SERVICE BULLETIN RELEASE - 02/25/2014

09-015/14 - 2014 MAZDA6 - HOOD VIBRATION ABOVE 68 MPH

Bulletin No: 09-015/14

Bulletin No: 01-001/14

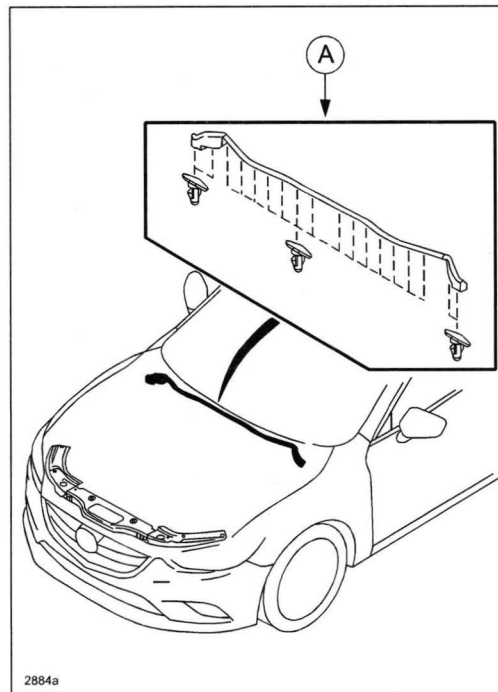
Some vehicles may exhibit a hood vibration when driving above 68 mph (110Km/h). This may be caused by a cowl grill that is not firmly attached.

1. Verify customer concern.
2. Replace the cowl grill seal (A). Refer to MS3 online or Workshop Manual (section 09-16 COWL GRILLE REMOVAL/INSTALLATION).

NOTE: The cowl grill seal is attached to the cowl grill with clips.

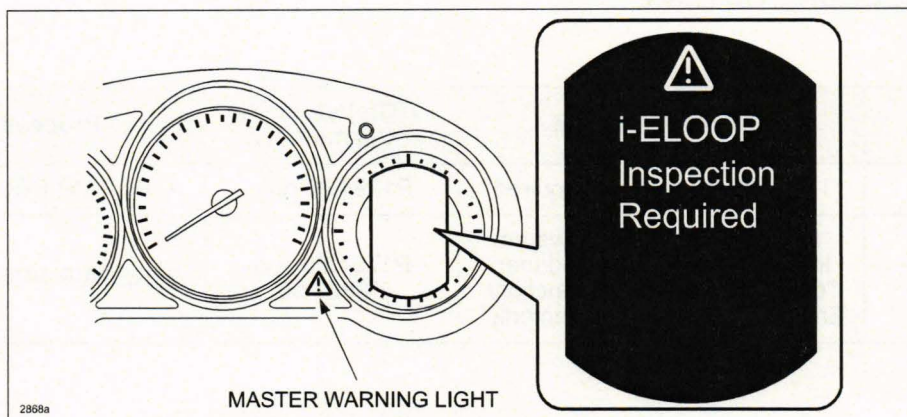
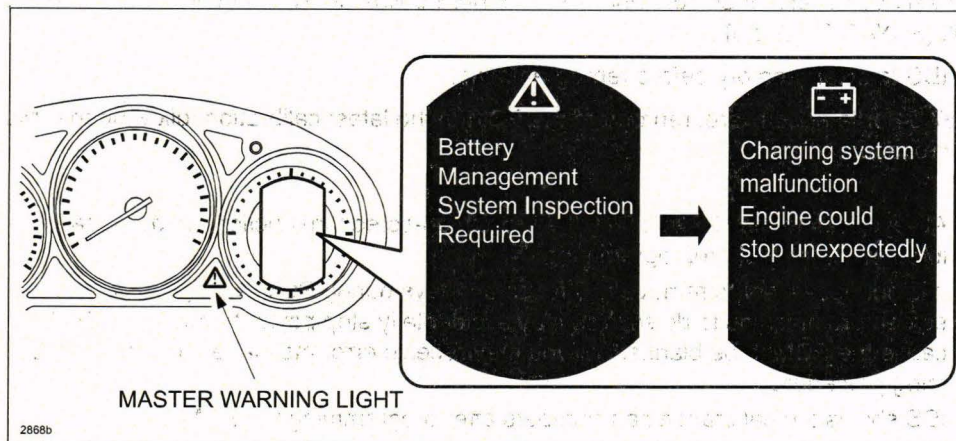
- This bulletin supersedes the previous bulletin 01-001/14, issued 01/24/2014, 01/10/2014 and 01-028/13, issued on 11/19/2013. The **APPLICABLE MODEL(S)/VINS, DESCRIPTION, REPAIR PROCEDURE** and **CALIBRATION INFORMATION** have been revised.
- Changes are noted below in Red beside the change bar.

- a. Warning message "i-ELOOP Inspection Required" is displayed in the instrument cluster information display while driving.
- b. The Master warning light will be illuminated.

- c. DTC P1794:00 (Capacitor (i-ELOOP) system: Capacitor (i-ELOOP) malfunction) will be stored in PCM memory.

Customers having this concern should have their vehicle repaired using A. REPAIR PROCEDURE.
